## RAISING CANE'S JSP25-14

Public Hearing at the request of Raising Cane's Restaurant for Planning Commission's consideration of Preliminary Site Plan and Special Land Use Permit. The subject property, 26245 Novi Road, contains a 3,795 square foot building on a 1.28-acre parcel within the TC, Town Center Zoning District. The applicant is proposing to convert a former Wendy's drive-through restaurant to a Raising Cane's drive-through quick-serve restaurant including modifications to accommodate improved drive-through and by-pass lanes, modifications to the building façade, and providing a covered patio with 20 seats.

### Required Action

**SITE KEYNOTE  
PLAN**  
SHEET NUMBER:  
**C5.0**

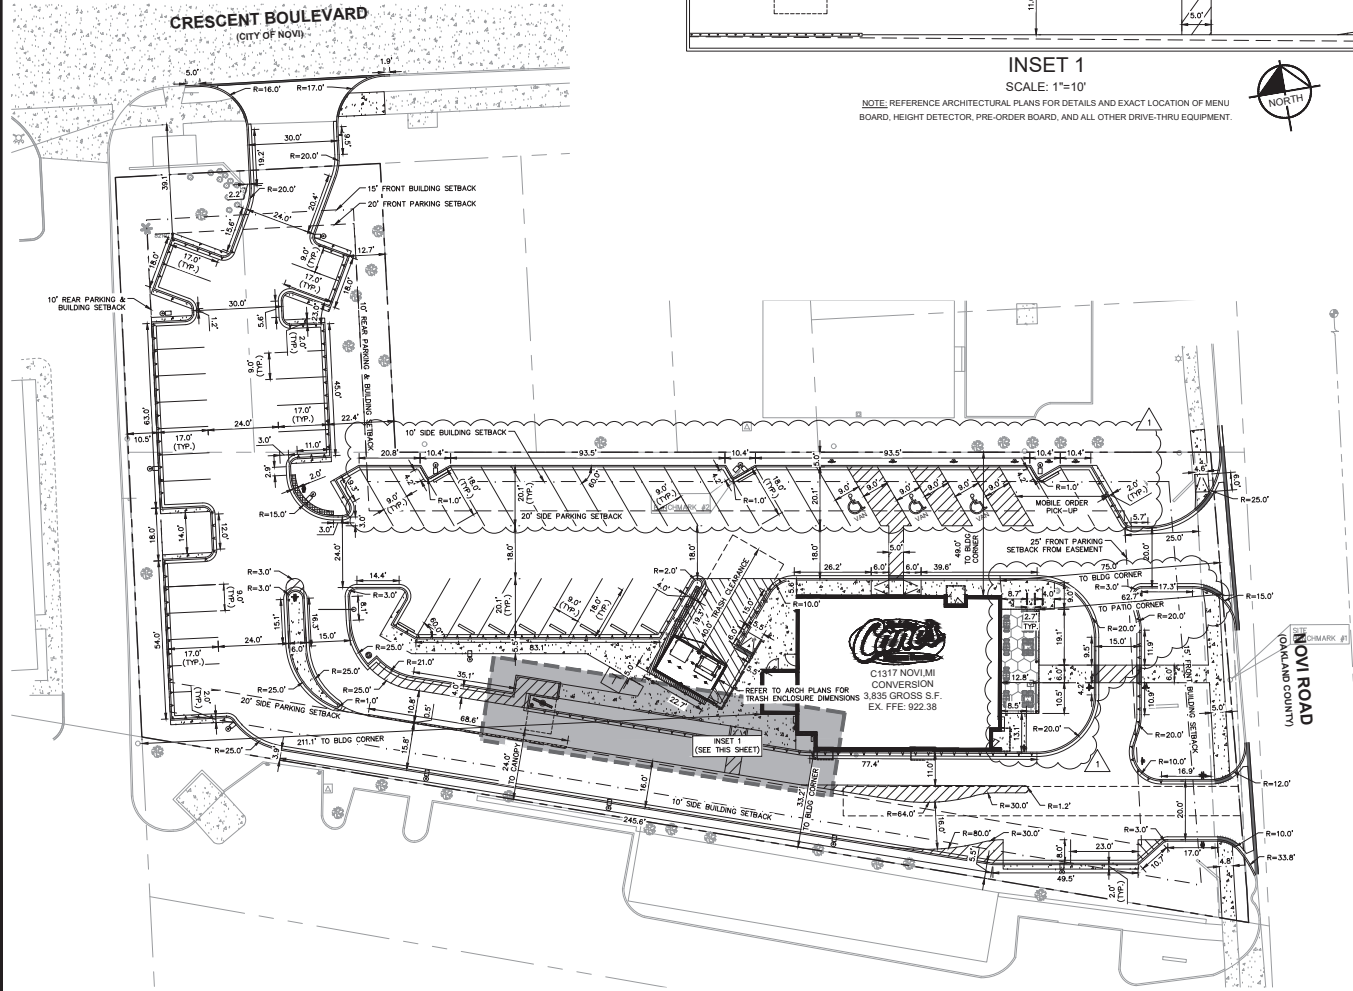
5. Architecture/Pedestrian Orientation (Sec. 3.27.1.E): The Site Analysis Table on Sheets C5.0 indicates 12 outdoor seats are proposed, but the provided Project Narrative and Framing Plan (Sheet A1.20) proposes it being 20 seats. Please update Site Analysis Table to include correct number of seats and outdoor patio square footage, and dimension the outdoor patio on both plans on next submittal.

8. Outdoor Seating (Sec. 4.40.3.B) - Please update Site Analysis Table on Sheet C5.0 to show correct number outdoor seats.

***Response: The Site Analysis Table on Sheet C5.0 – Site Keynote Plan will be updated to match the Project Narrative and Sheet A1.20 Framing Plan, with 20 seats proposed within the outdoor patio. Dimensions of the outdoor patio will be included on Sheet C5.1- Dimension Control Plan and Sheet A1.20 – Framing Plan.***

***Response: The Site Analysis Table on Sheet C5.0 – Site Keynote Plan will be updated to show the correct number of outdoor seats.***

FRAMING PLAN

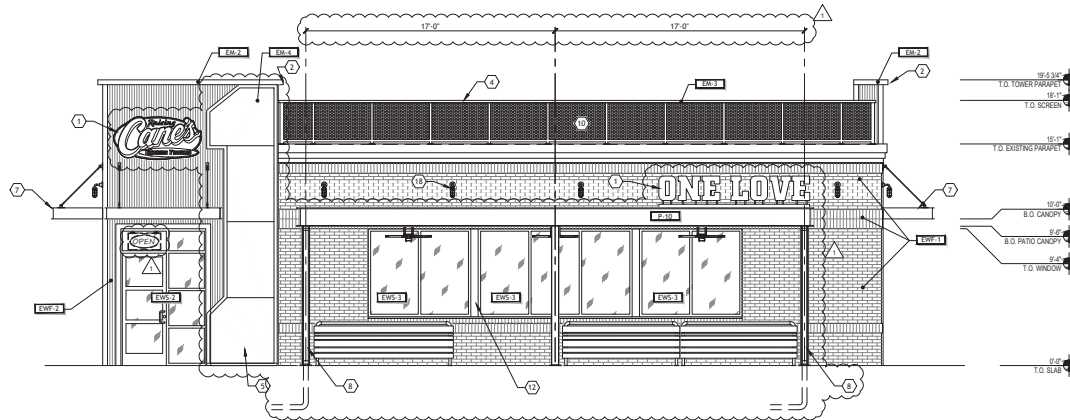
2. Architecture/Pedestrian Orientation (Sec. 3.27.1D): The Site Analysis Table on Sheet C5.0 indicates 12 outdoor patio seats are proposed, but the Project Narrative and Framing Plan (Sheet A1.20) proposes it containing 20 outdoor seats. – **Please update Site Analysis Table to include correct number of seats and outdoor patio square footage, and dimension the outdoor patio on both plans on next submittal.**

5. Lighting Plan (Sec. 5.7.2.A.ii): A partial lighting plan was provided, but a full plan is required at the time of Final Site Plan review. The site plan previously proposed relocating at least one light pole but now proposes replacing all 15 light poles and bases using code compliant LED fixtures per updated Project Narrative. However, the lighting plan provided is missing significant details. Additionally, the Hours of Operation provided in the Project Narrative and Framing Plan (Sheet A1.20) show conflicting hours of operations.

1. Architecture/Pedestrian Orientation (Sec. 3.27.1D): The Site Analysis Table on Sheet C5.0 indicates 12 outdoor patio seats are proposed, but the Project Narrative and Framing Plan (Sheet A1.20) proposes it containing 20 outdoor seats – **Please update Site Analysis Table to include correct number of seats and outdoor patio square footage, and dimension the outdoor patio on both plans on next submittal.**  
***Response: The Site Analysis Table on Sheet C5.0 – Site Keynote Plan will be updated to include the correct number of seats and outdoor patio square footage. Dimensions of the outdoor patio will be included on Sheet C5.1- Dimension Control Plan and Sheet A1.20 – Framing Plan.***

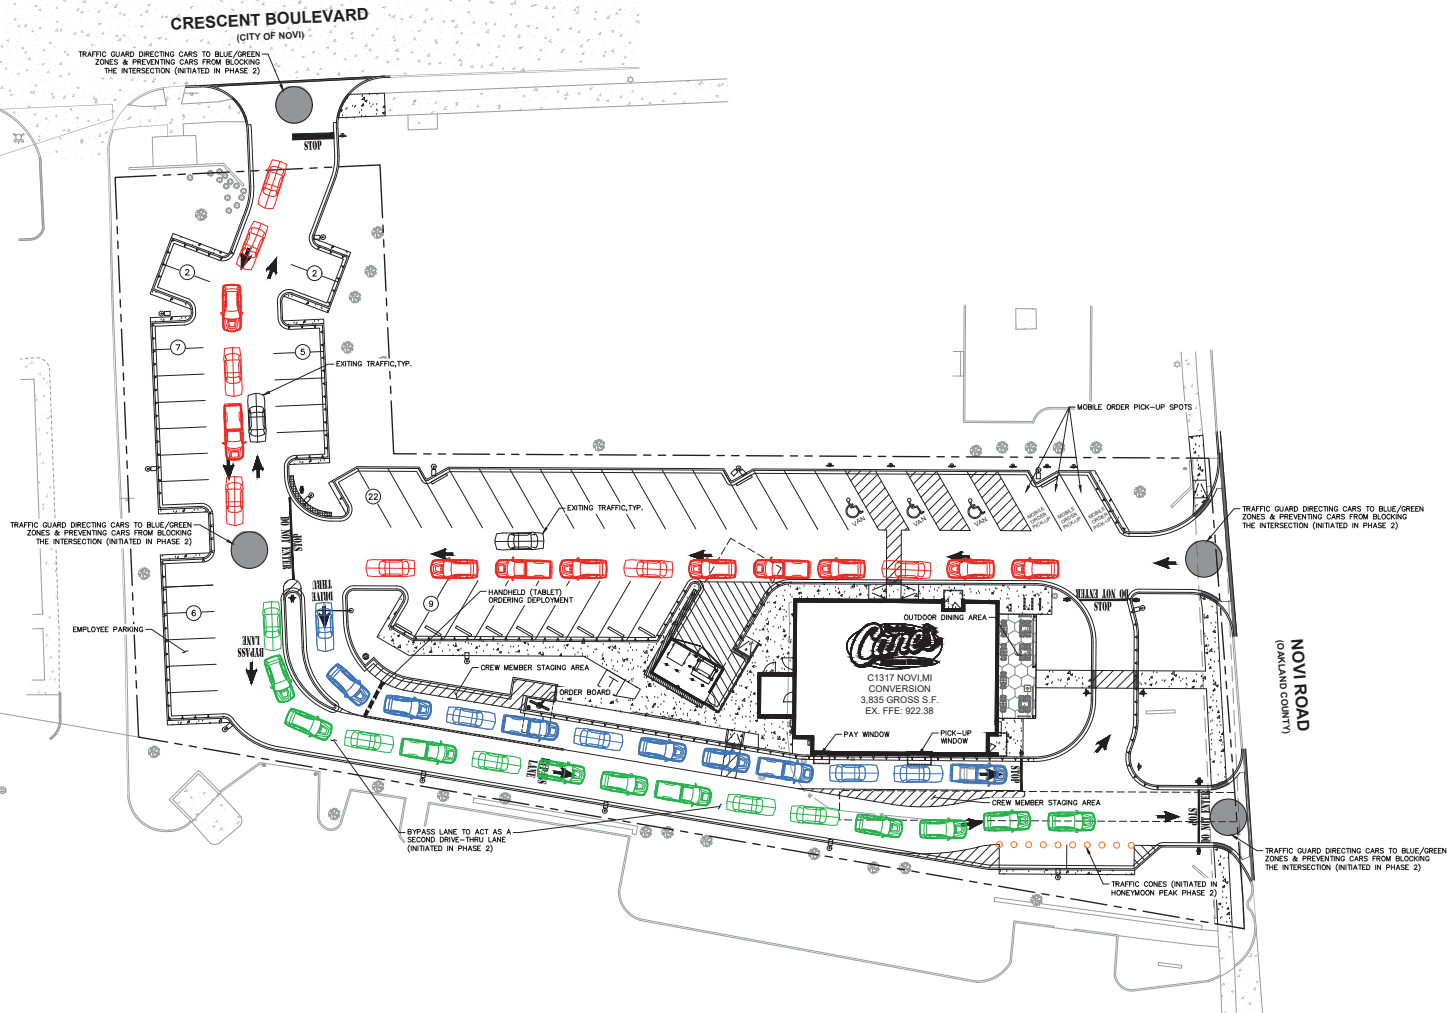
Traffic	Approval Recommended	8-4-2025	<ul style="list-style-type: none"> <li>• <b>A Drive-Thru Queuing Plan for Grand Opening Peak was requested and reviewed</b> – supported by the City's Traffic consultant</li> </ul>
Façade	Approval Recommended	8-5-2025	<ul style="list-style-type: none"> <li>• <b>Section 9 Façade Waiver is required for the "1" logo proposed on the side of the building</b> – supported by the City's façade consultant</li> </ul>
Fire	Approval Recommended	7-31-2025

- g. Contingent on the applicant executing the proposed Drive-Thru Phased Queuing Plan for Grand Opening Peak, and is supported by staff, the Fire Marshal, and the City's traffic consultants;
